ADDENDUM # 2

Bid 17C8, Butterfly Ridge Elementary School – New School Construction
REVISED DUE DATE: January 26, 2017

BUTTERFLY RIDGE ELEMENTARY – NEW SCHOOL CONSTRUCTION

**BUTTERFLY RIDGE ELEMENTARY SCHOOL
BID PACKAGE
ADDENDUM NO. 2
21347.00**

ADD 2
SKA-2.1

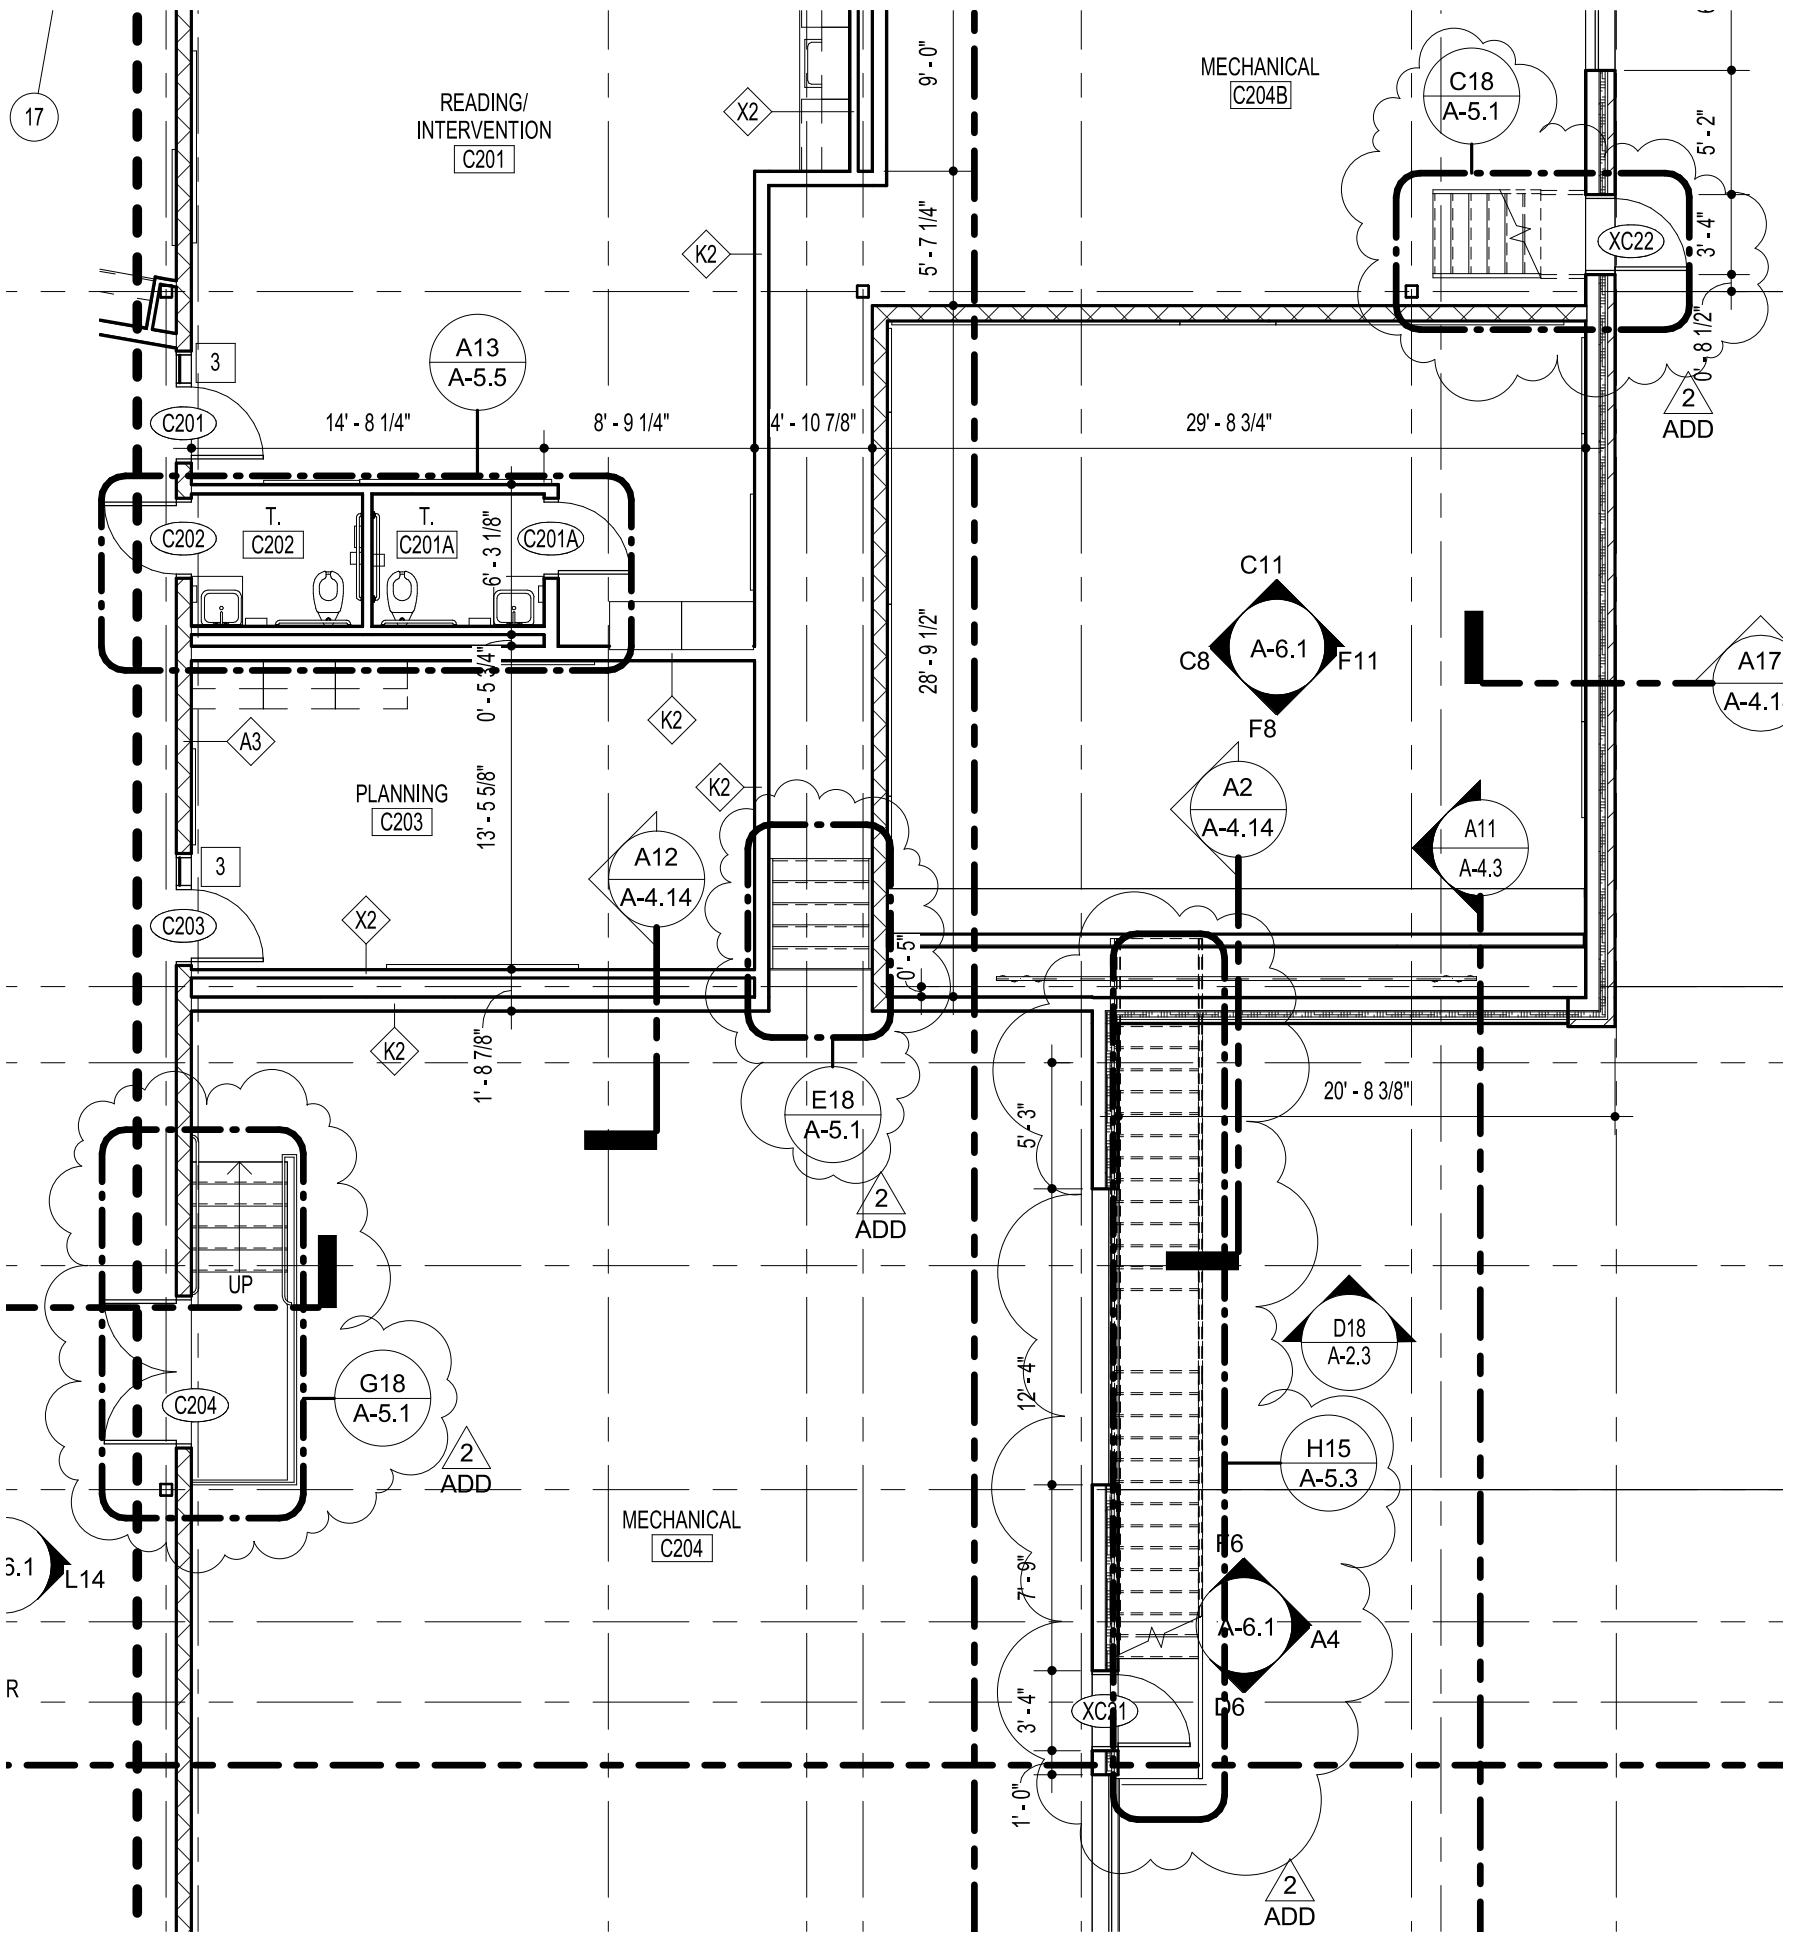
ITEM NO. A2: SHEET A-1.3 PARTIAL FIRST FLOOR PLAN-AREA C1
REVISE Plan A15 per attached sketch SKA-2.1.

ADD 2
 SKA-2.2

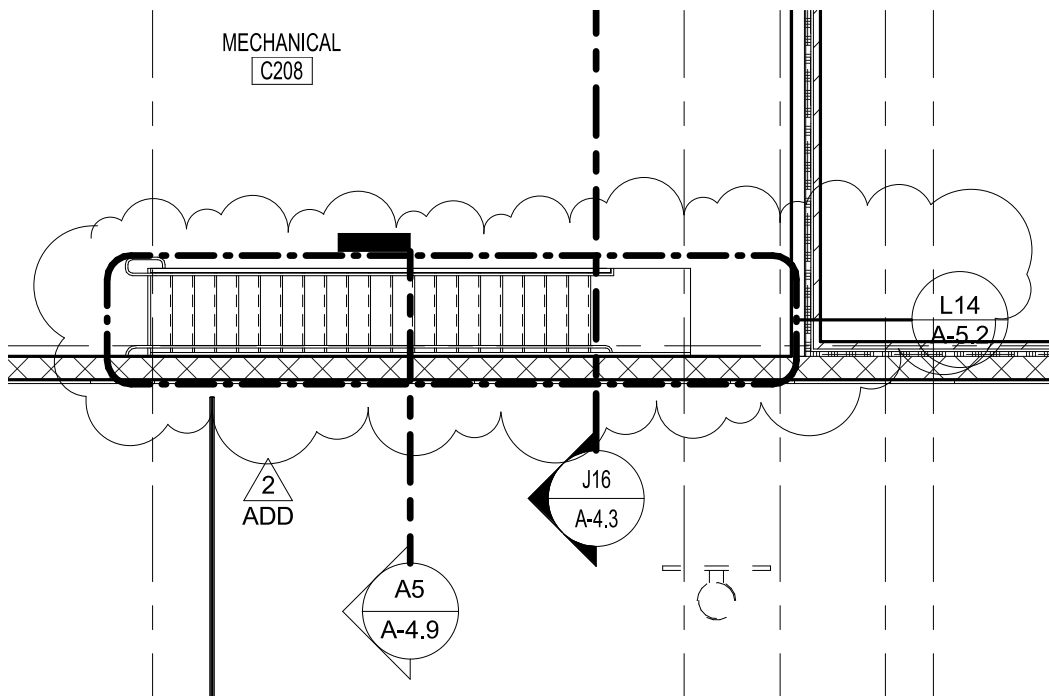
ITEM NO. A3: SHEET A-1.7 PARTIAL SECOND FLOOR PLAN-AREA C1
REVISE Plan A14 per attached sketch SKA-2.2.

ADD 2
SKA-2.3

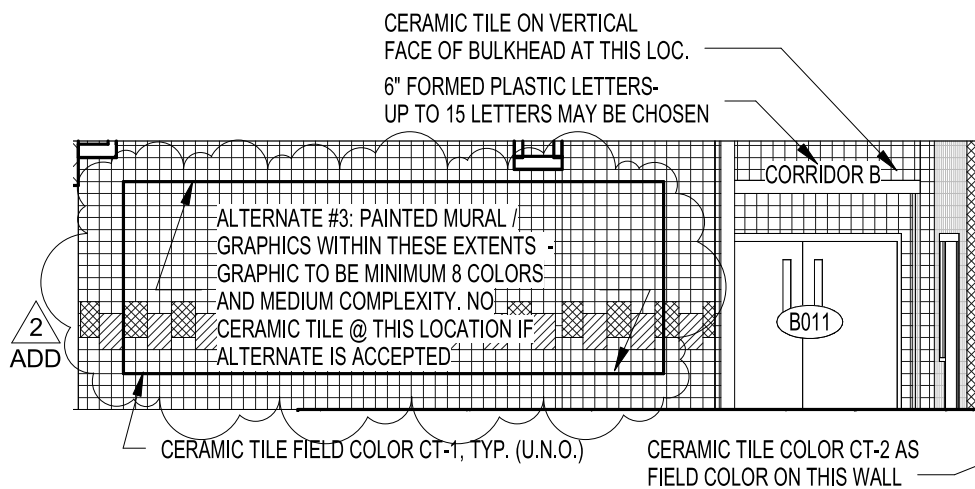
ITEM NO. A4: SHEET A-1.8 PARTIAL SECOND FLOOR PLAN-AREA C2
REVISE Plan A17 per attached sketch SKA-2.3.

ADD 2
SKA-2.4

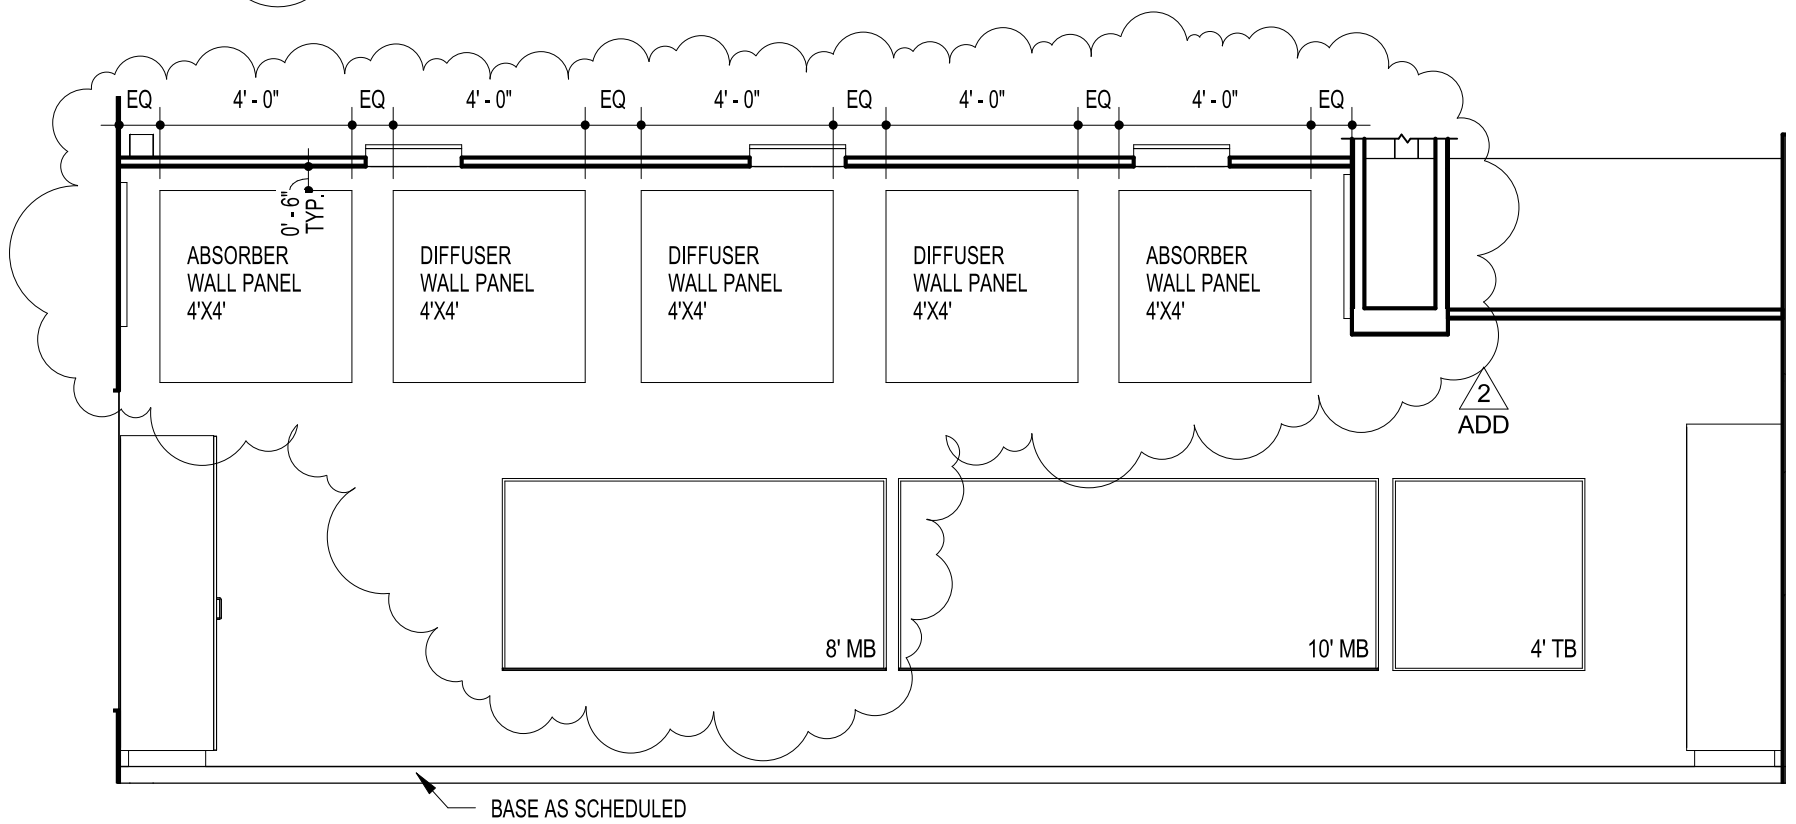
- ITEM NO. A12: SHEET A-6.1 INTERIOR ELEVATIONS
REVISE Elevation J14 per attached sketch SKA-2.4.
- ITEM NO. A13: SHEET A-6.2 INTERIOR ELEVATIONS
REVISE Elevations A18 and C18 per attached sketch SKA-2.5.
REVISE Elevations E18 and G18 per attached sketch SKA-2.6.
